Duke Power Company
P.O. Box 33198
Charlotte, N.C. 28242

Subject: McGuire Nuclear Station, Units 1 and 2
Docket Nos. 50-369 and 50-370
ASME Section XI Hydrostatic Testing Requirements
Relief Request No. 89-02, Revision

Present Piping Configuration

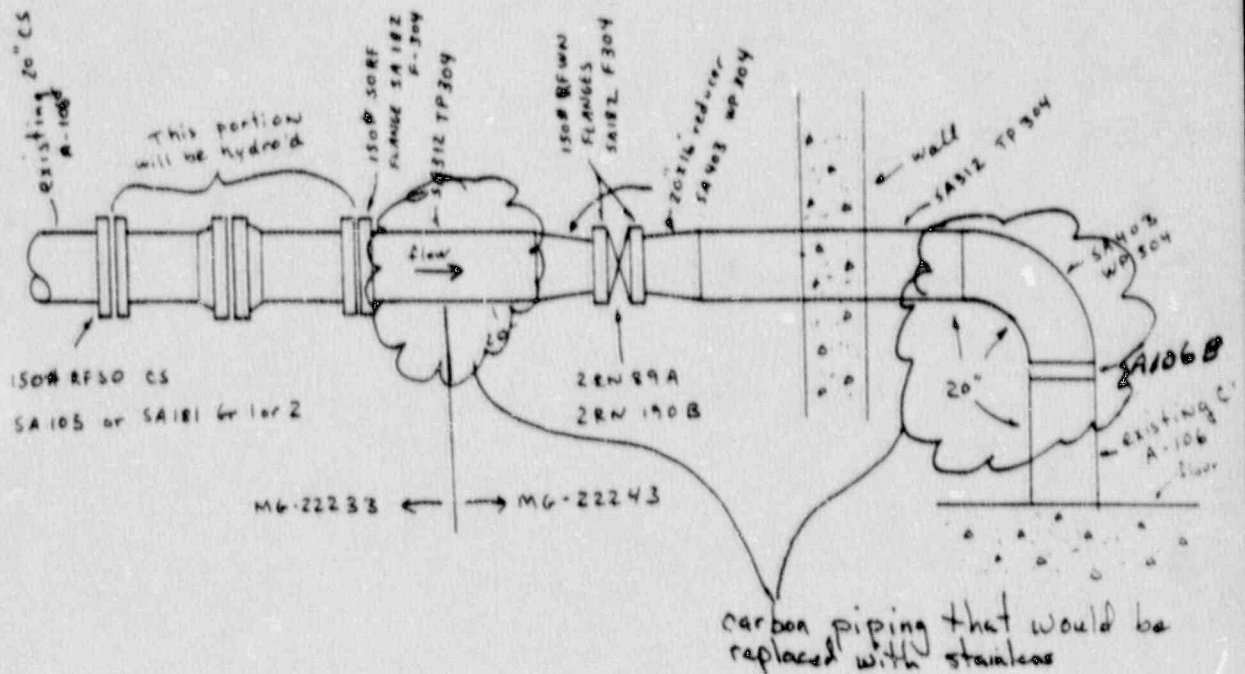
In the original scope of the modifications, we planned to replace some carbon steel piping with stainless steel (SS) piping. In an effort to further reduce corrosion/erosion associated with carbon piping, we have made additional changes to the modifications that would replace a 20 inch carbon steel 90 degree elbow pipe with SS pipe. Additionally we plan to replace another straight section of 20 inch carbon pipe with SS pipe (see attached drawing for details). The connections will be made using groove welds. In lieu of hydrostatic testing, all welds in the modification will be subjected to a dye penetrant or magnetic particle examination on root pass and finished weld. An in-service leak test will further verify the new connections do not leak.

Piping Configuration After Implementation
of MG-22233 Rev.0 and MG-22243 Rev.0
Station Modifications.
